ADDENDUM NUMBER: 5
PROJECT: **UNC Charlotte Residence Hall Phase XIV - Early Site Packages**

DATE: **March 4, 2015**
OWNER: **UNC Charlotte**
ARCHITECT: **FWA Group**

Early Site Package Pre-Bid RFI #1

Early Site Package Pre-Bid RFI #2

S401

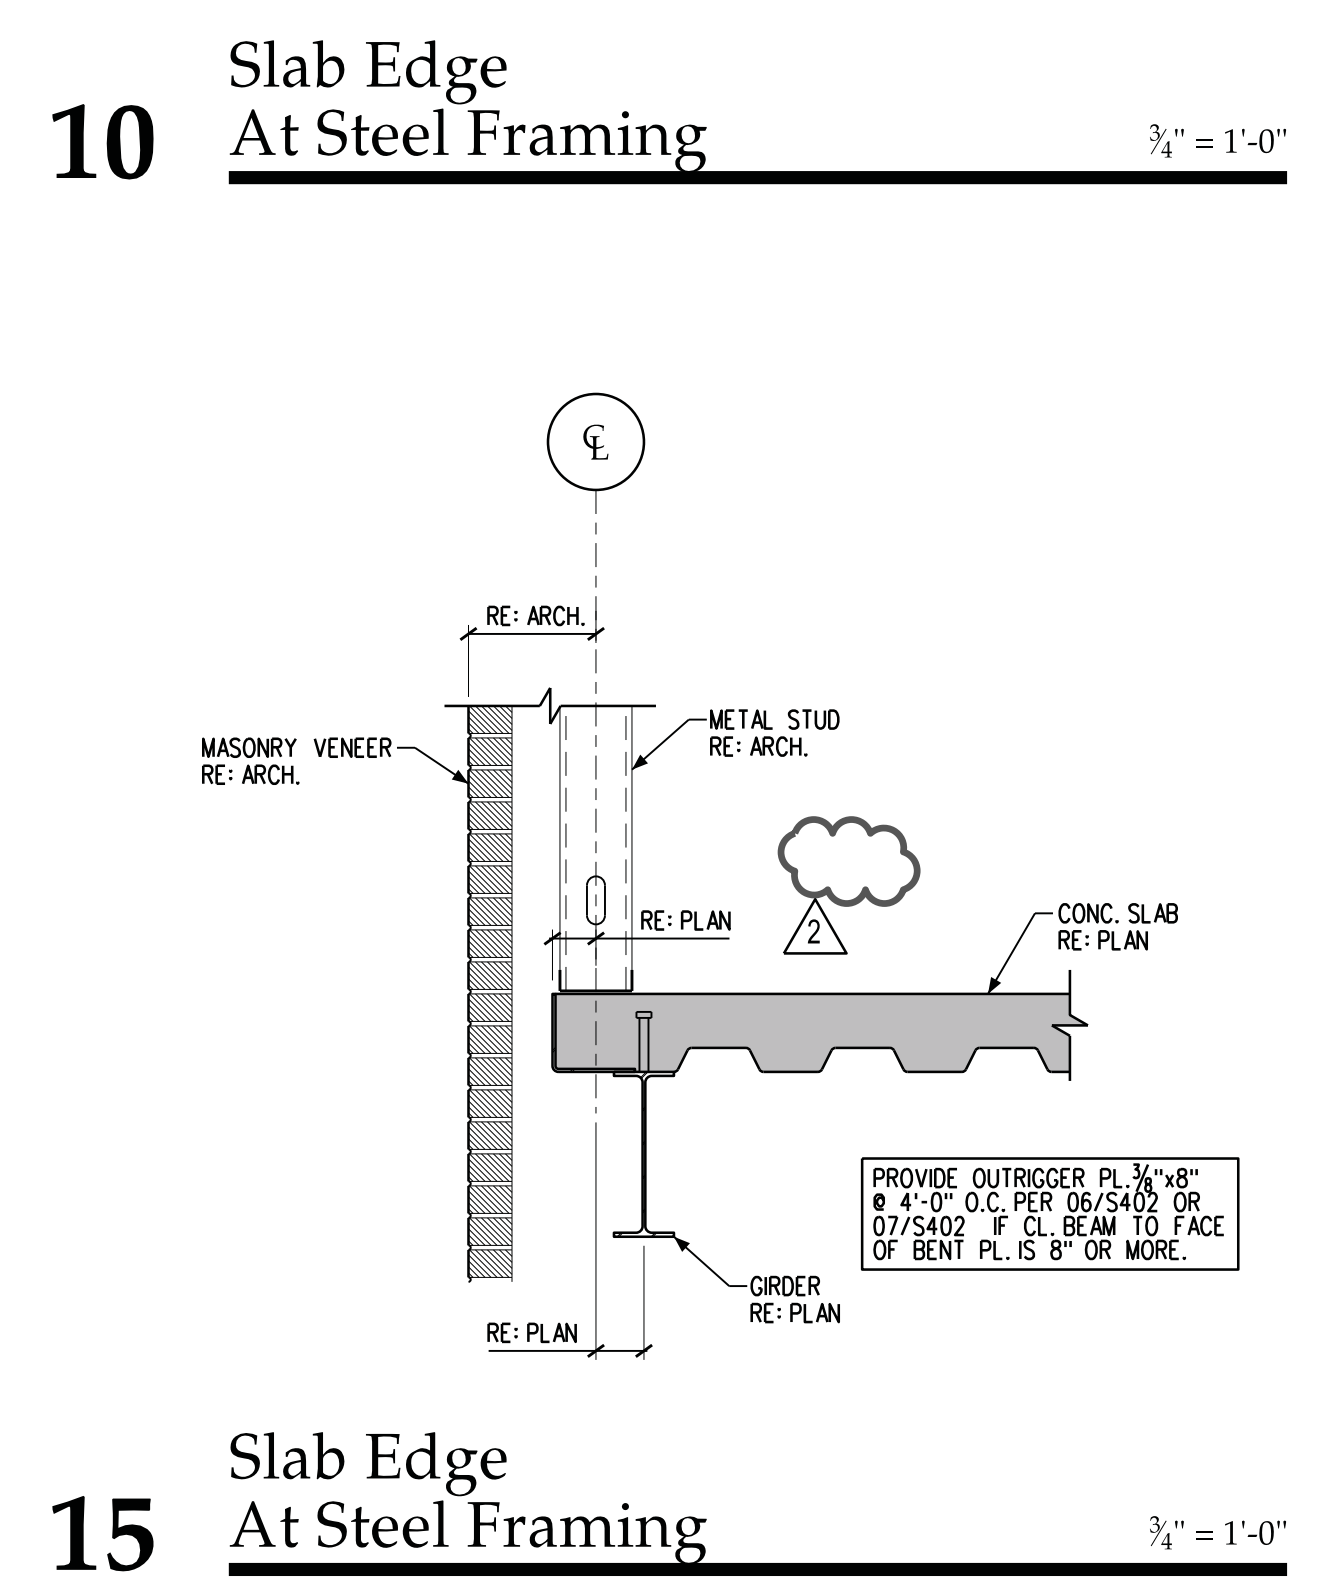
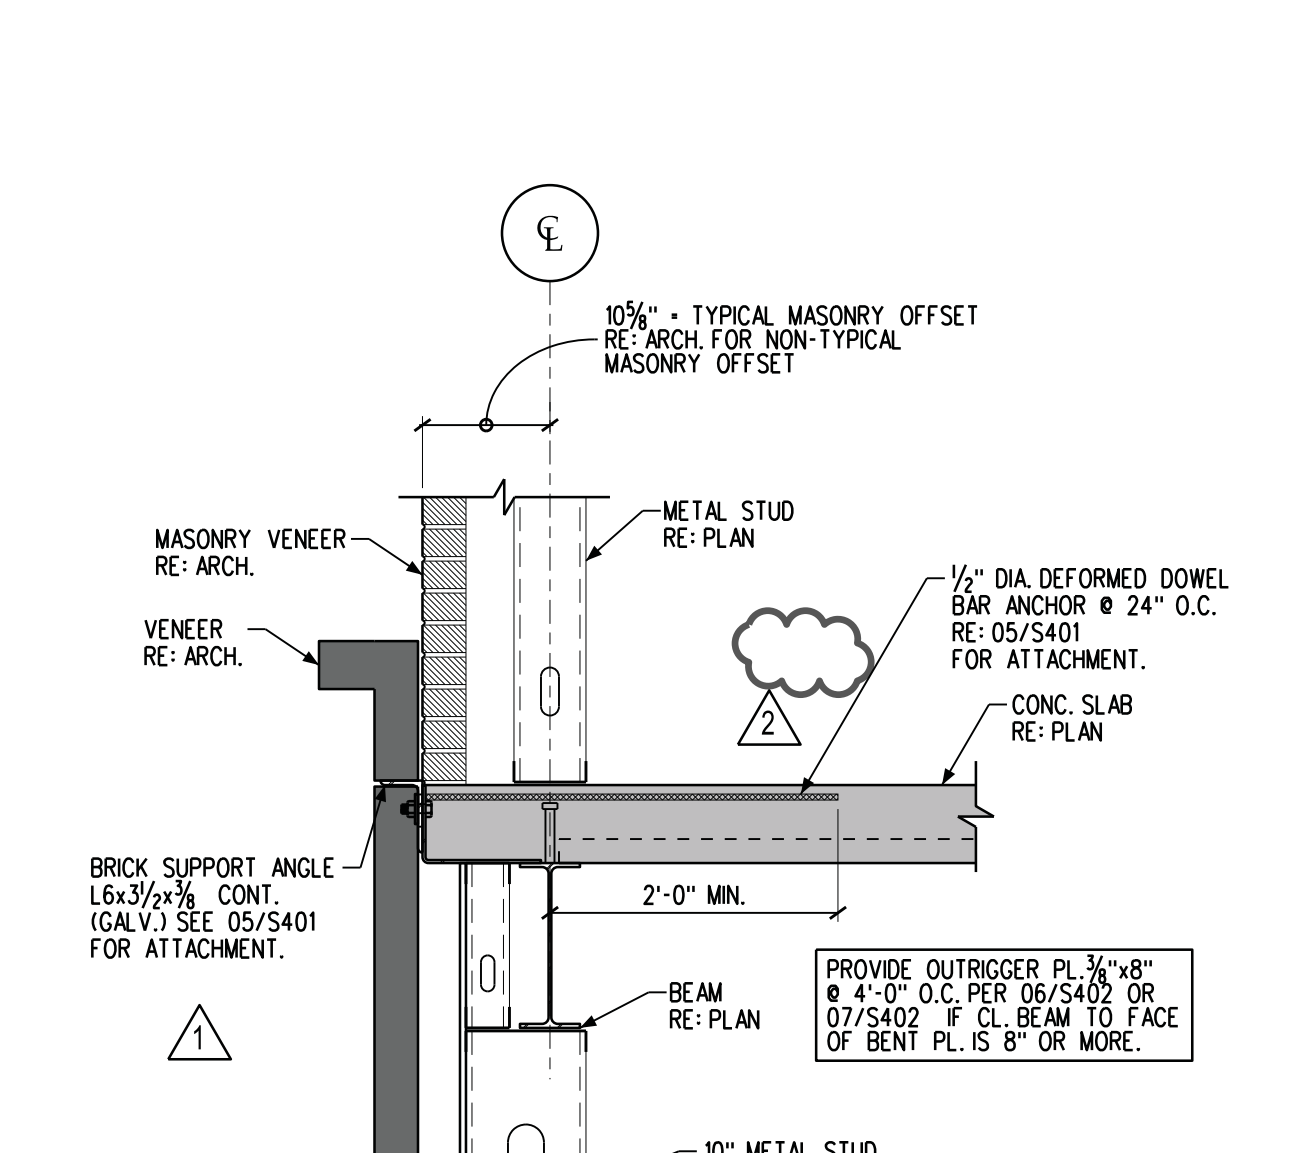
Answer:	BSDE Response: Typical slabs <u>over structural steel framing</u> do not require WWF. However, construction joints in slabs do utilize WWF as detailed on 03/S402. NOTE: Elevated slabs supported by CFS framing (using dovetail deck) DO REQUIRE WWF as indicated. We have removed the WWF depiction from details 03, 04, 06, 07, 10, & 15 on S401. The WWF in detail 01/S401 is correct. See FWA Addendum #02.
24	Section 2/S303 at 27 & 28 line on sheets 203-N, 204-N, and 205-N does not appear to be correct. Please verify call out.

Answer:	BSDE Response: The reference has been revised to read 02/S401 at these locations. See FWA Addendum #02.
25	Detail 5/S403- please verify shear wall anchor welded to steel are by 05A
